CONTRACT ID NO. 151246

ADDENDUM # 1

Subject: Bullitt County, STP BRZ 0503 (240)

WATER MAIN RELOCATION

ITEM NO. SHEET NO. COUNTY OF BULLITT 5-1081.00 U2

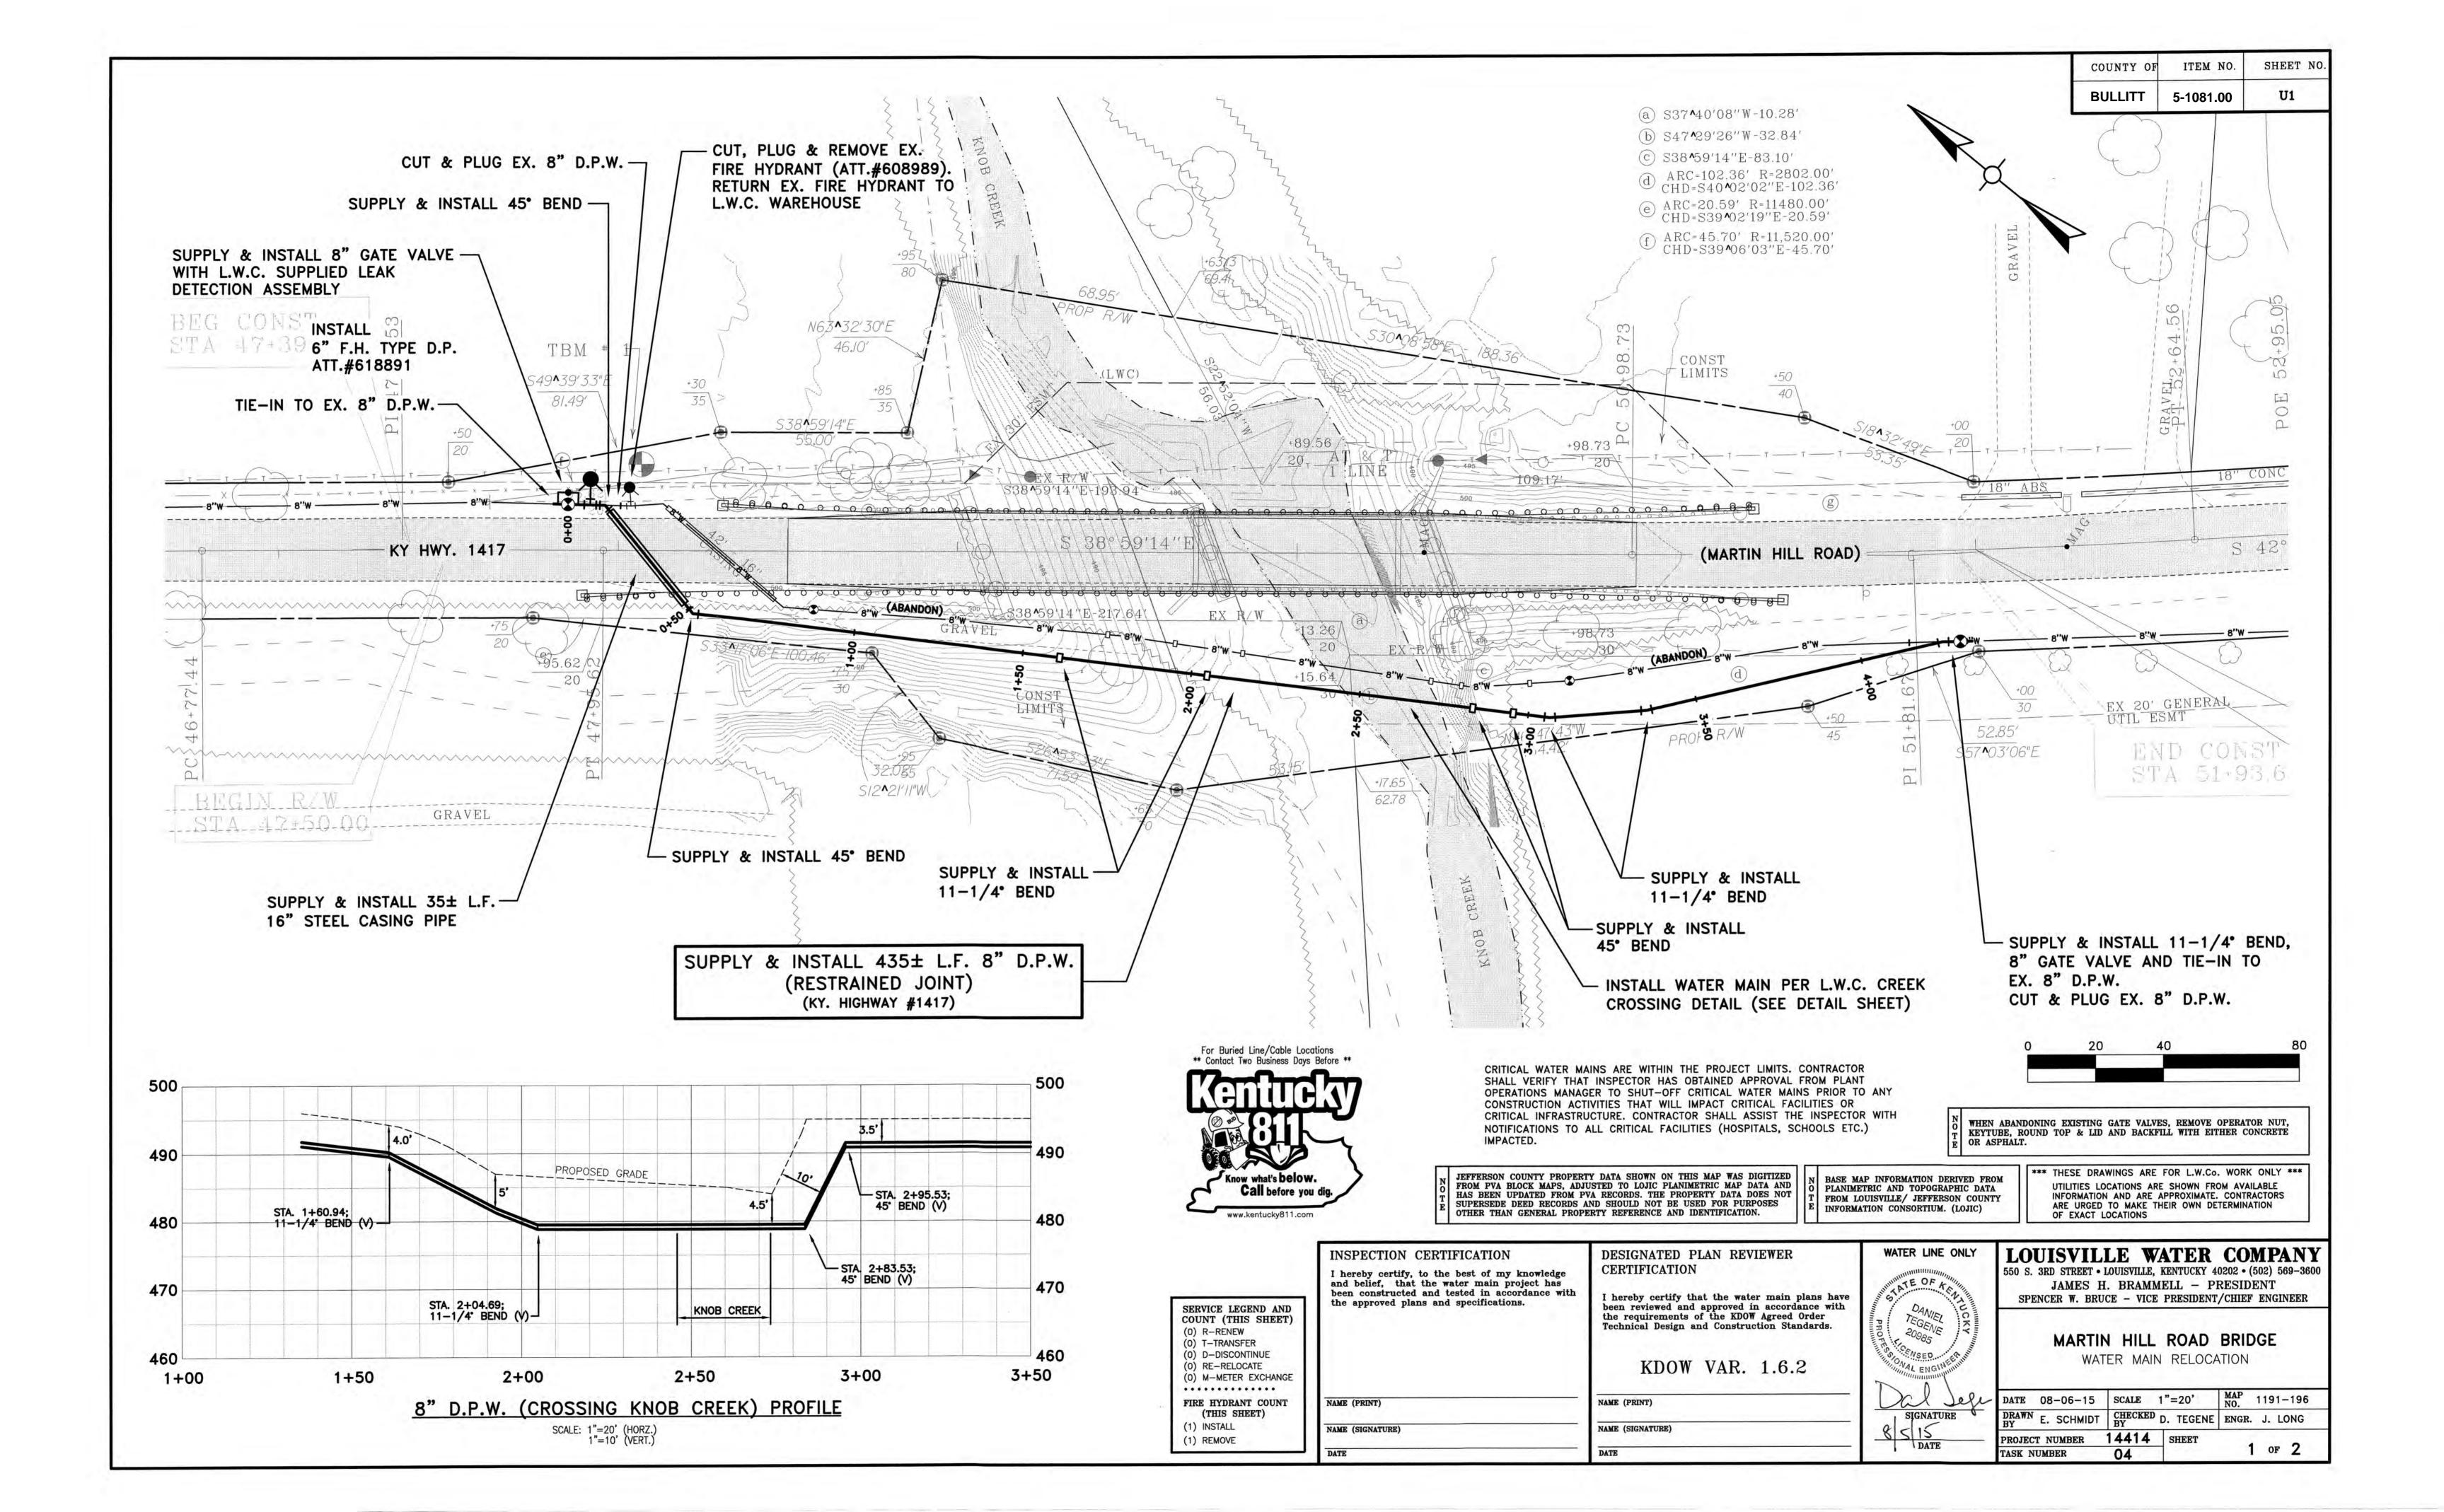
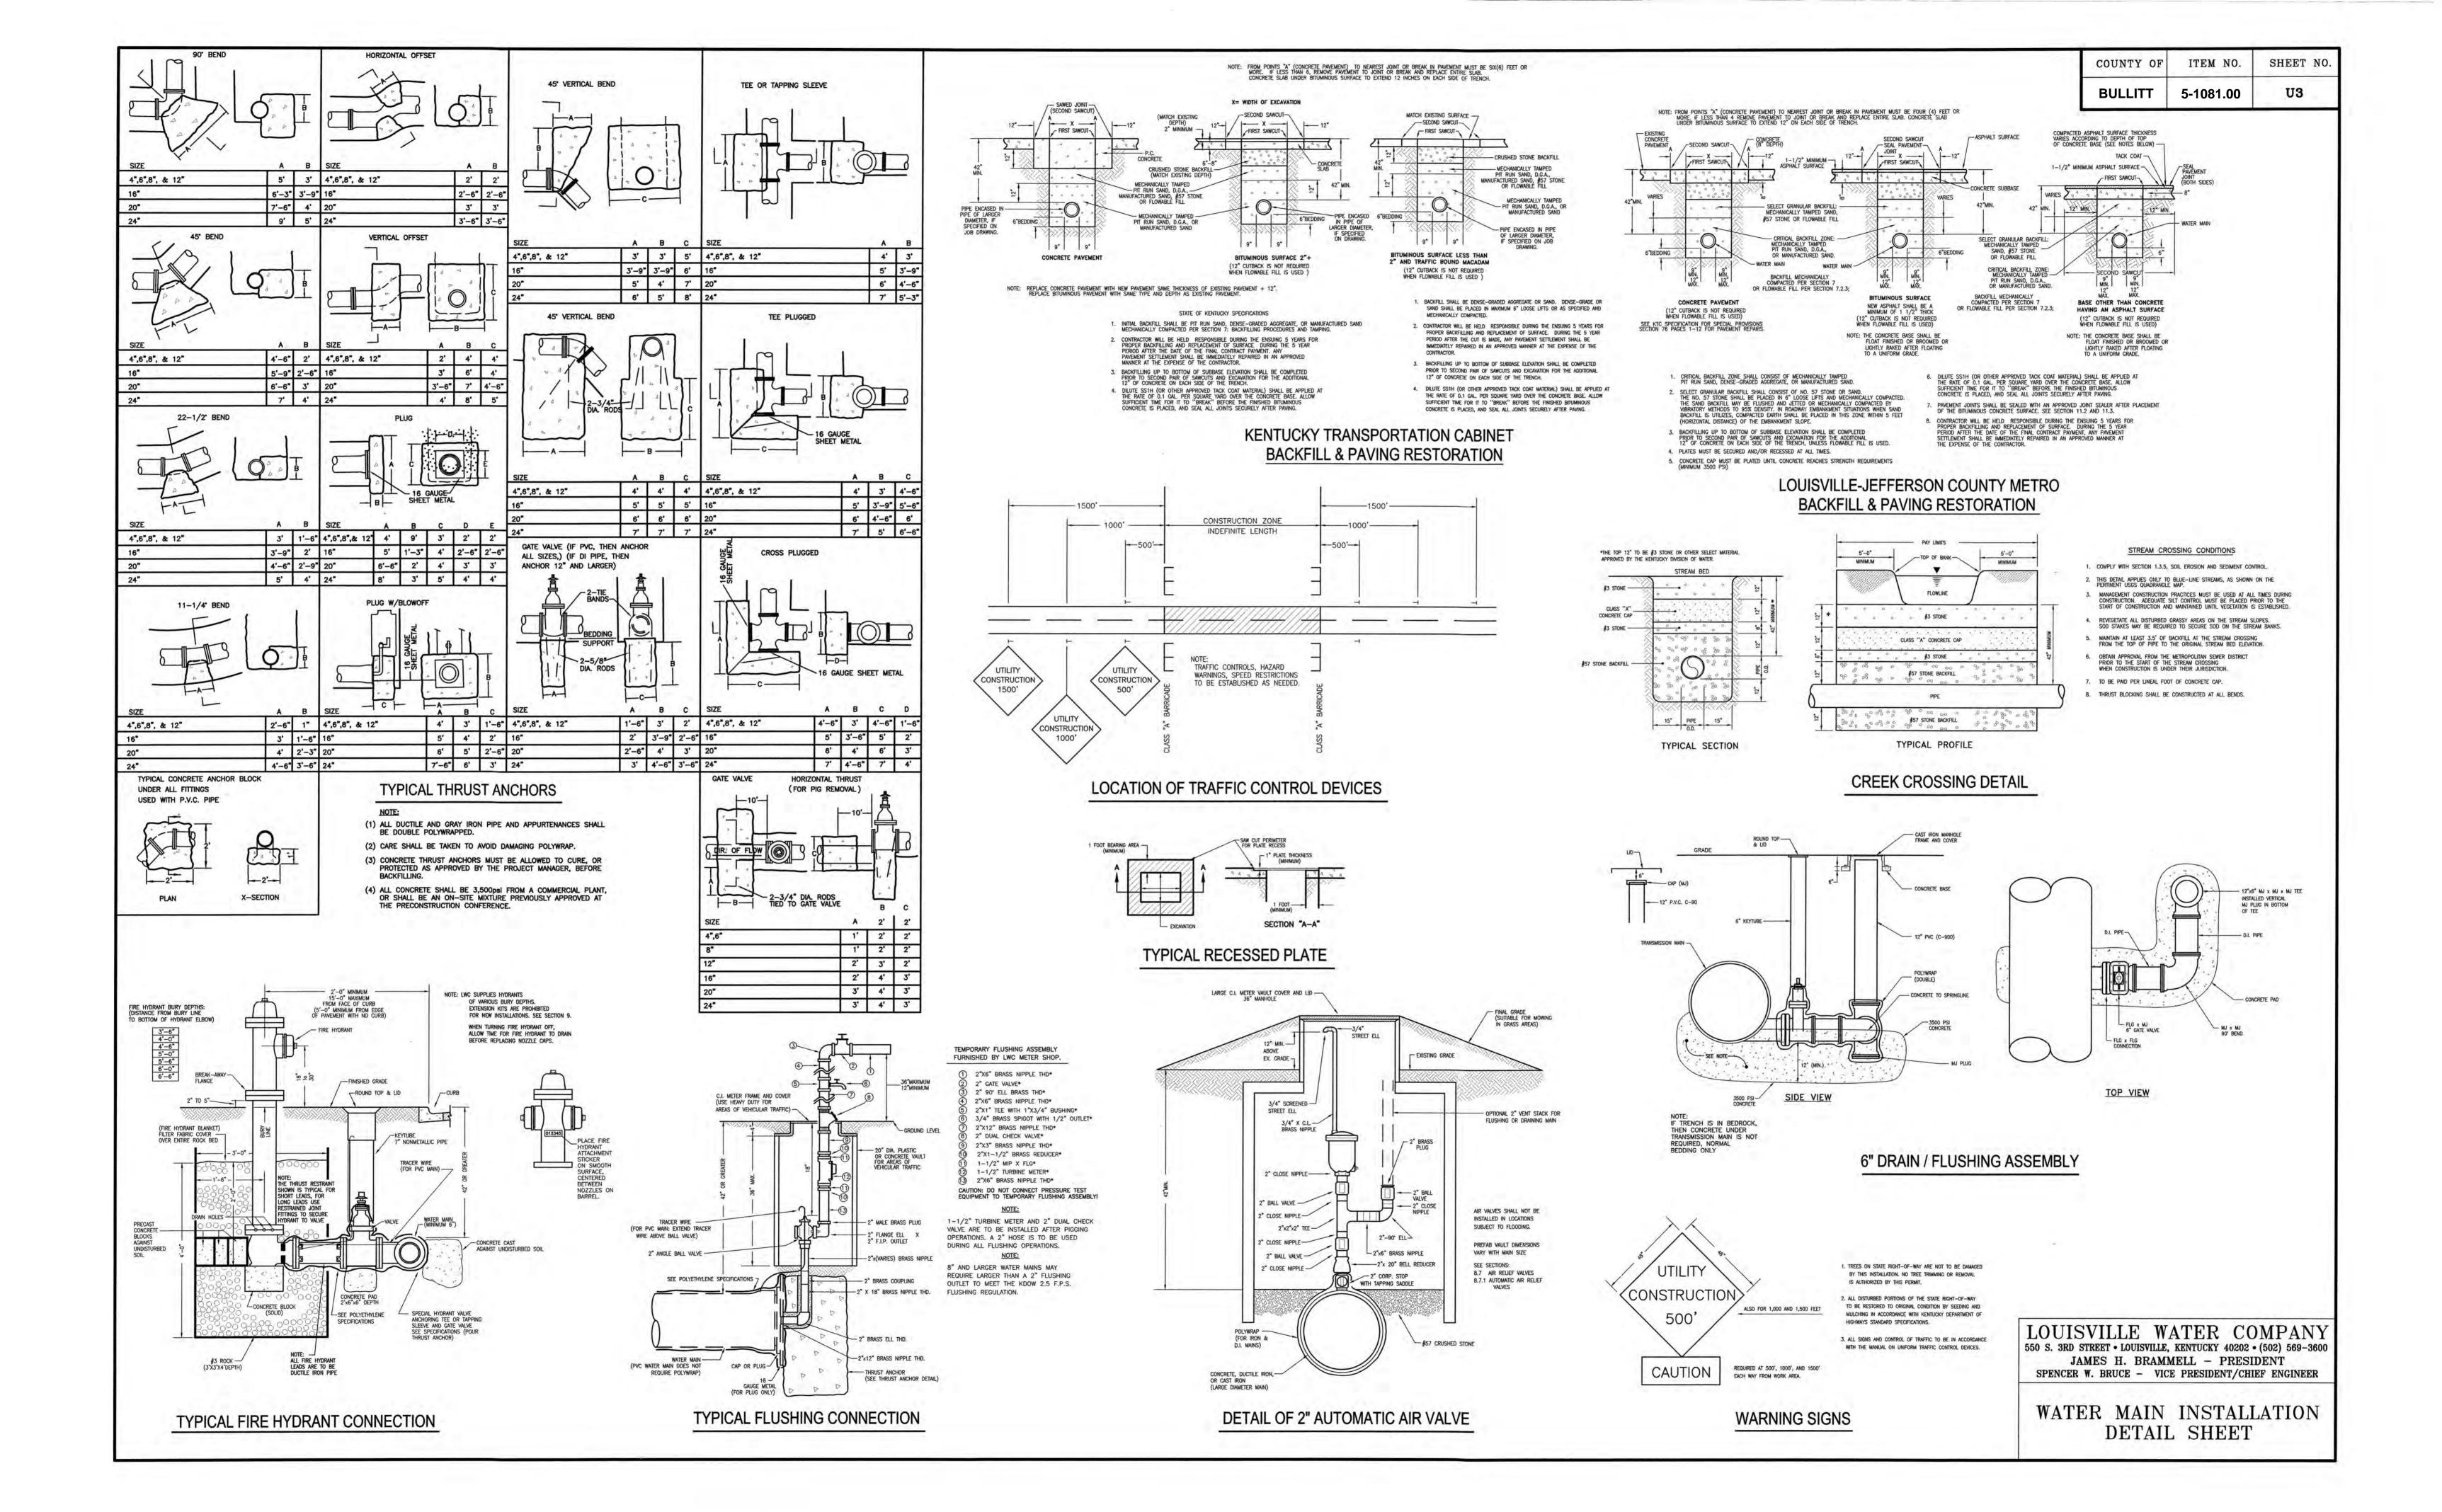
(1) Replace - Plan Sheets - U1, U2, & U3
